NINE MILE POINT NUCLEAR STATION

SUBJECT: Nine Mile Point Nuclear Station
Unit No. 2, Docket No. 50-410

License Amendment Request Pursuant to 10 CFR 50.90: Request for Adoption of
Technical Specification Task Force Traveler TSTF-514, Revision 3, "Revise BWR
Operability Requirements and Actions for RCS Leakage Instrumentation"

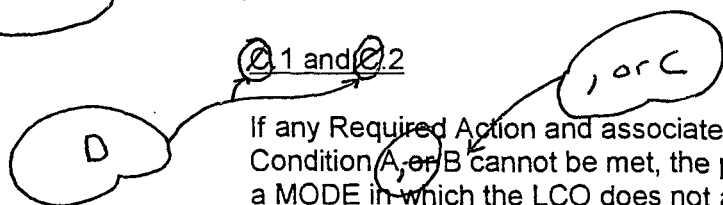
With the drywell floor drain tank fill rate monitoring system inoperable, the only means of detecting LEAKAGE is the drywell atmospheric gaseous radioactivity monitor. A Note clarifies this applicability of the Condition. The drywell atmospheric gaseous radioactivity monitor typically cannot detect a 1 gpm leak within one hour when RCS activity is low. In addition, this configuration does not provide the required diverse means of leakage detection. Indirect methods of monitoring RCS leakage must be implemented. Grab samples of the drywell atmosphere must be taken and analyzed and monitoring of RCS leakage by administrative means must be performed every 12 hours to provide alternate periodic information.
